JASIC Opinions on ETRTO/LINK's proposed revision to the vehicle method

Opinions on ETRTO's proposal(TA-36-3)

Opinions on LINK's proposal(TA-36-9)

Minimal average temperature test for Normal/Y tyres

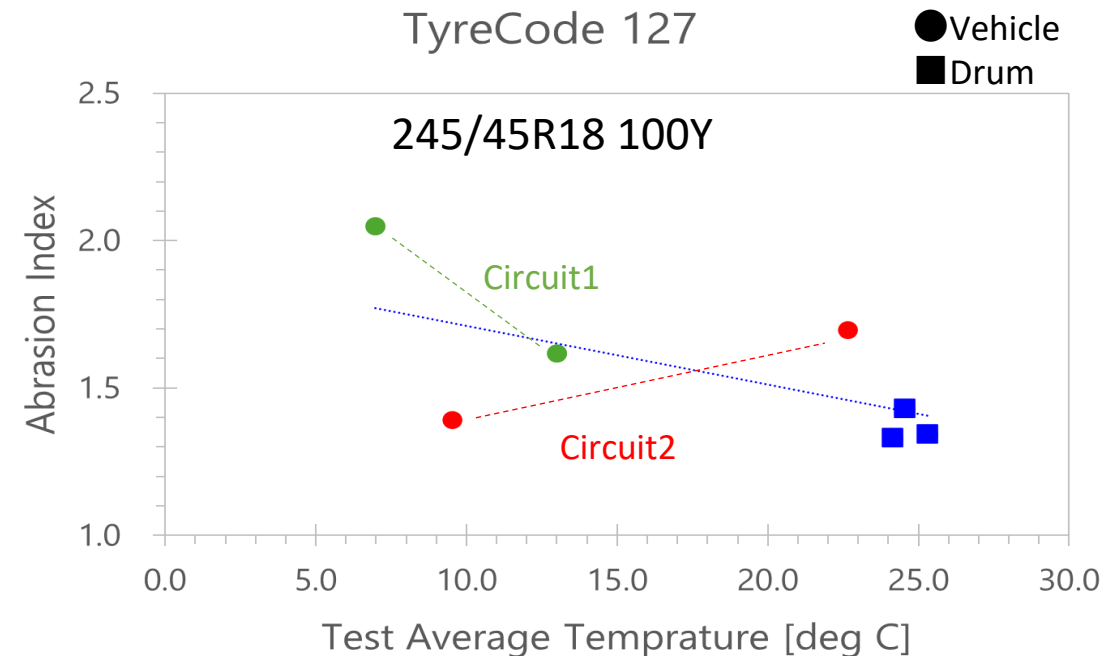
- Issue:
 - The average test temperature currently allowed should be above 7°C for Normal tyres
 - During the correlation test, 2 tyres with speed index Y has shown a high abrasion rate index at temperature around 7°C, and a much lower abrasion rate index at any higher test temperatures

- Proposal
 - Normal tyres to be tested with an average temperature above 10°C and Y speed index tyres above 12°C (instead of 7°C)
- Impact : decrease uncertainties. For Validation test, decrease the Sigma by **0.04**

- The reason for changing the temperature of only Y speed index tyres is unclear.
- The changes in the index and temperature differ for each circuit, and the difference in the index is not solely due to the influence of temperature. Therefore, this proposal will not improve accuracy.
- The specified temperature range may be too wide. It is necessary to judge based on individual data, including not only the average but also the maximum and minimum specifications for the 90% of test distance.

- Implementation in the annex 3, paragraph 1.7.1:
 - The average temperature during the test shall be within the following range: from 10 °C to 35 °C; However, for tyres with speed index Y, the minimal average temperature during the test shall be 12 °C

- The minimum and maximum temperature during the test shall be within the following range: from 5 °C to 40 °C for at least 90 per cent of test distance; However for tyres with speed index Y, the minimal temperature for at least 90 per cent of test distance during the test shall over 7 °C

Circuit length, New definition

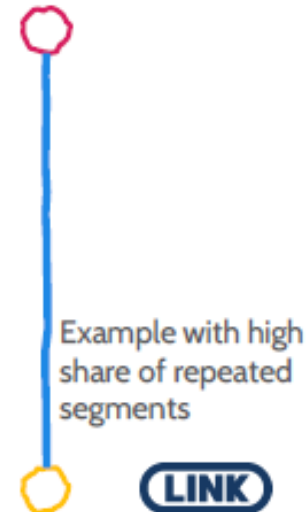
- Remove unnecessary definitions (Loop, etc.).
- Proposal to introduce measure for avoiding repetition of road segments
- Keep existing cycles compliant (DEKRA, IFV, LINK, UTAC,...)

- Regarding the removal of unnecessary definitions, we agree if it does not affect other provisions.
- Regarding the introduction of measure for avoiding repetition of road segments, we agree if sections that are the same but run in different directions are treated as different roads.

1.11.10 Vehicle trouble handling

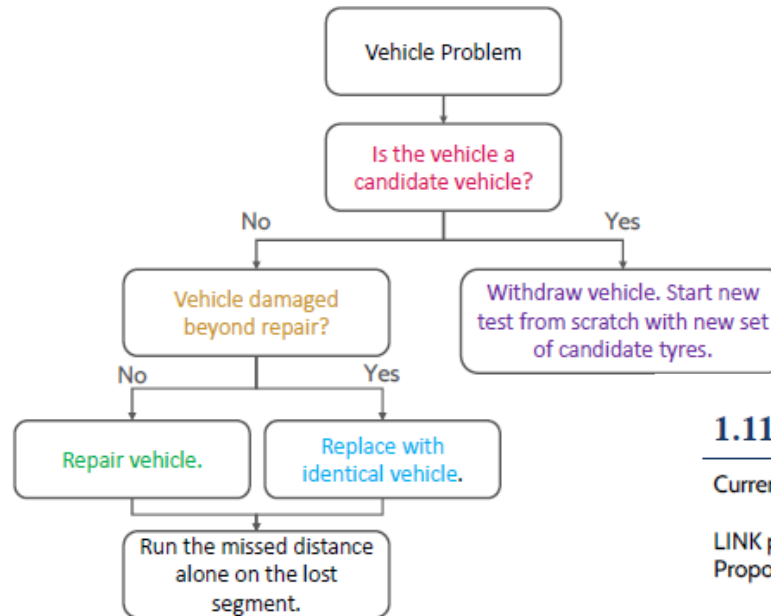
- (a) If a vehicle used in the convoy is damaged and cannot be used anymore (e.g. major mechanical failure or accident), it shall be replaced by an identical vehicle that shall be identically loaded and tuned. The replacement vehicle, equipped with the same tyres having started the test, shall run the distance lost due to vehicle failure on the lost segment of the circuit alone without the other vehicles of the convoy;
- (b) If a vehicle used in the convoy is broken down and can be repaired, the lost distance shall be run without other convoy vehicles on the lost segment of the test circuit;
- (c) If the failure occurs on a candidate vehicle and not on the reference vehicle, the convoy may continue the test and the failing vehicle/tyre shall be withdrawn from the convoy. A new set of candidate tyres shall then be used for a new test, starting from scratch.

- JASIC opposes both the current provisions and Link's proposal. We are concerned that testing only repaired vehicles could lead to abuse of the provisions. If a vehicle experiences a problem, the test of the tyres installed on that vehicle should be invalidated.
